TYPE NO <b>CV7200 CV7300</b>	TYPE <b>Coffe Vending Machines</b>	T.I. NO <b>02</b>				
SERIAL NUMBERS AFFECTED <b>From and including S/N 30311536</b>	ISSUED BY <b>Documentation/N&amp;W Valbrembo</b>					
SUBJECT <b>GRIP step 2</b>		ISSUED FOR (X): <table border="1"> <tr> <td>Action</td> <td></td> </tr> <tr> <td>Information</td> <td><b>X</b></td> </tr> </table>	Action		Information	<b>X</b>
Action						
Information	<b>X</b>

## HEADLINE

- In all CV7200 and CV7300 machines from serial number 30311536 , the branch pipe, mixer cover fixation , CPU board and the overflow have been modified.

- Branch pipe

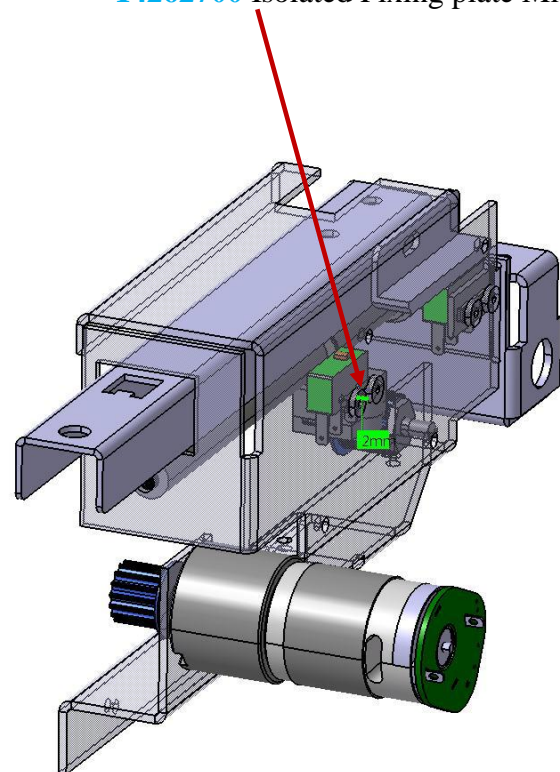
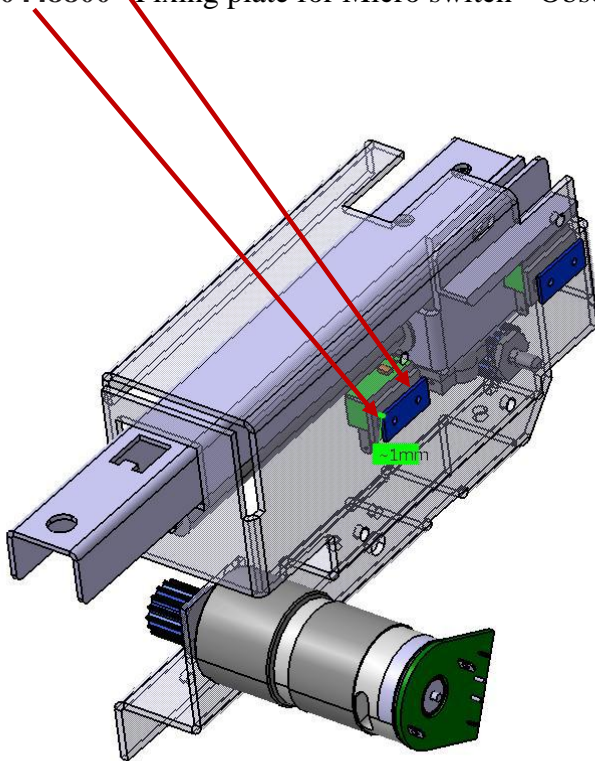
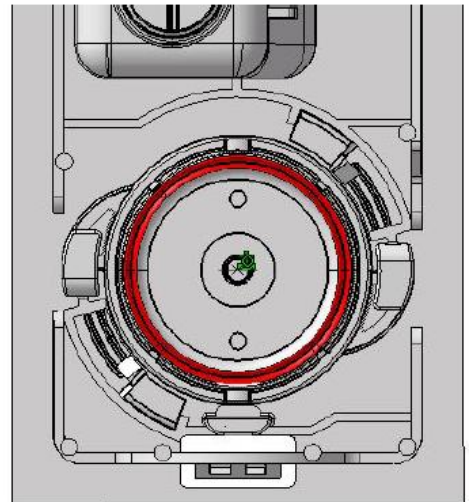
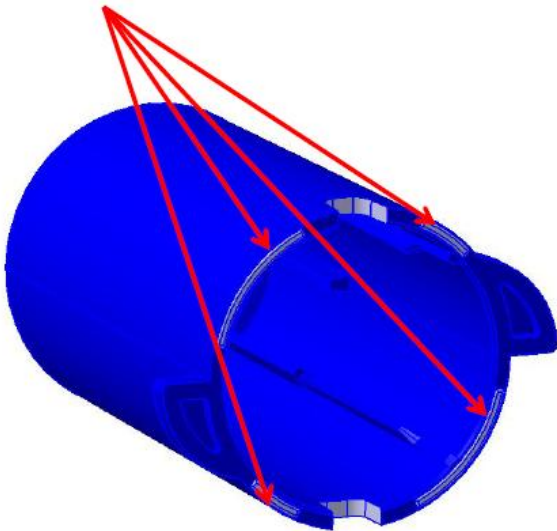
- The metal plate is replaced by a insert in order to increase the thickness up to 2mm and a thread holder;

- Too little material thickness for the thread of the screw (1mm): the thread gets easily damaged and the fixing is not working anymore

- 
- 14262700** Isolated Fixing plate Micro

**COMPONENTS CONCERNED** - mixer cover fixation  
 • Mixer cover

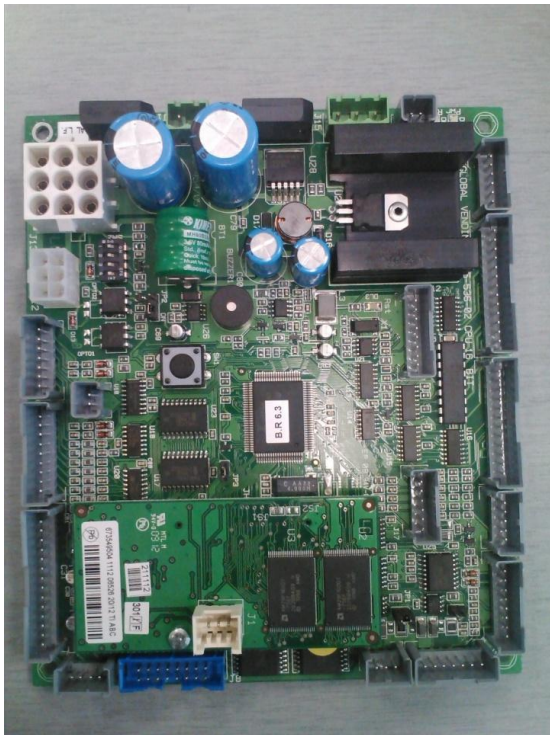
- To prolong the lifetime of the V-ring and mixer motor and reduction of the sound pressure

- TOO HIGH VIBRATION

## COMPONENTS CONCERNED - CPU board

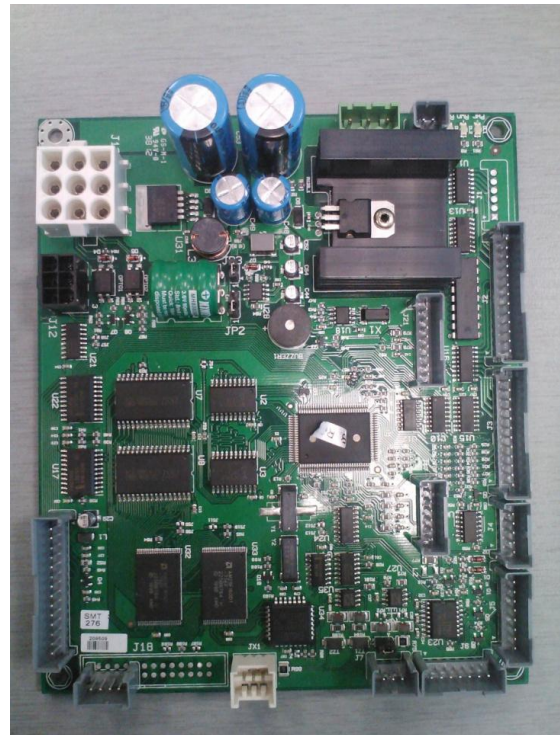
- CPU board Re-design integrating flash board on CPU board, optimizing the electronic components and the signal-communication

- In same case wrong initialing and not perfect communication between flash board and CPU board.

## COMPONENTS CONCERNED – Overflow OVERFLOW CIRCUIT OF BOILER

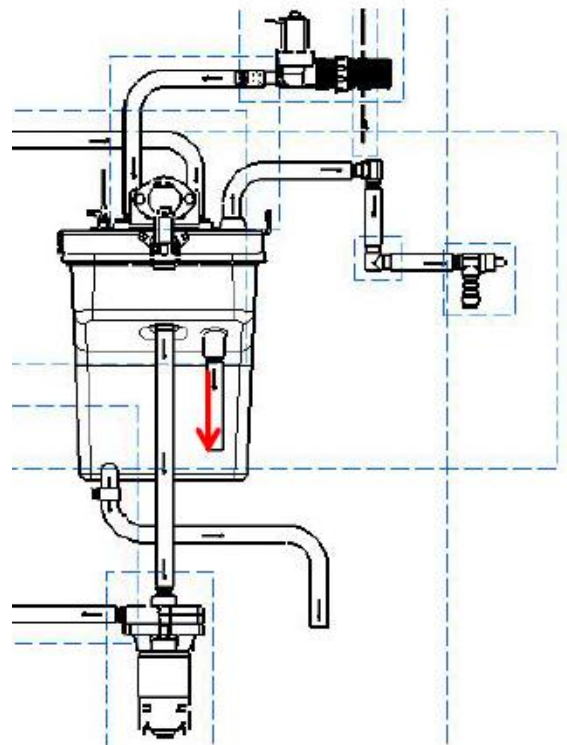
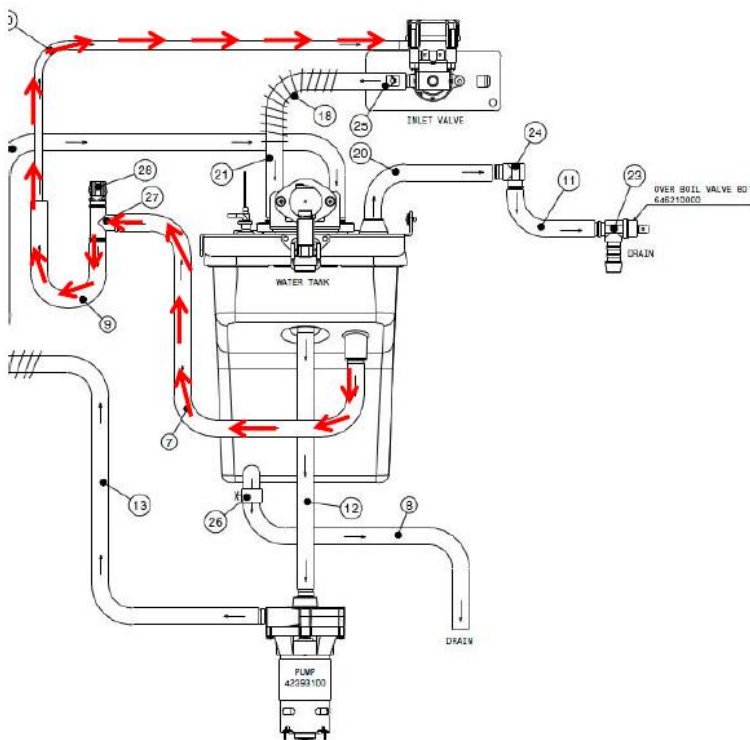
- The flow back to the inlet valve has been removed: the overflow is directed on the plastic bottom plate.

- Sometimes the overflow safety mechanism is activated even if there's not a flow issue. This causes mechanical blocking of the machine.

**256558** Inlet valve 24VDC UF 7100  
(the previous inlet valve had not spare code)
